Amendments to the Drawings

Remarks

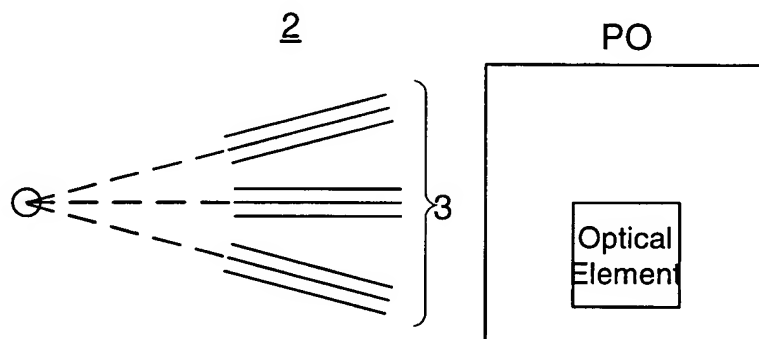
The drawings were objected to under 37 C.F.R. 1.83(a) for allegedly not showing every feature of the claimed invention. The Office Action indicated that the following features must be shown or the features canceled from the claims: (1) the processing organ; (2) the plurality of plates positioned substantially parallel to one another; (3) the lithographic apparatus and at least one optical element; and (4) plates positioned substantially orthogonally to another plate. Applicant traverses.

The disclosure was objected to because of the conflicting recitations in column 3, lines 23-30. In particular, the cited portions of the

specification recite a filter wherein "a plurality of plates are positioned substantially parallel in relation to one another," and that "such a separate filter is characterized in that the plates are directed radially from the radiation source." Applicant has amended the specification at the Examiner's request. Accordingly, this objection should be withdrawn.

Solely to expedite prosecution, Applicant has amended the drawings as directed by the Office Action. In particular, Fig. 1 has been amended to show a processing organ PO, such as a lithographic apparatus having an optical element (e.g., a mirror), as described in at least col. 1, lines 11-29, and 42-45; and col. 3, line 54-col. 4, line 3. Fig. 4 has been newly added to show a plurality of plates positioned substantially parallel to one another, as described in at least col. 3, lines 23-30. Furthermore, the second drawing of Fig. 3, for example, shows one or more plates positioned substantially orthogonally to another plate. Accordingly, this objection should be withdrawn.

However, Applicant does not relinquish, for example, an embodiment of a filter having both a plurality of plates positioned substantially parallel in relation to one another and plates directed radially from the radiation source.

For example, the above illustration shows an embodiment having three groups of plates, wherein each group of plates has a plurality of plates positioned substantially parallel in relation to one another and each group of plates is directed radially from the radiation source. Of course, this embodiment also depicts plates directed away from the radiation source.
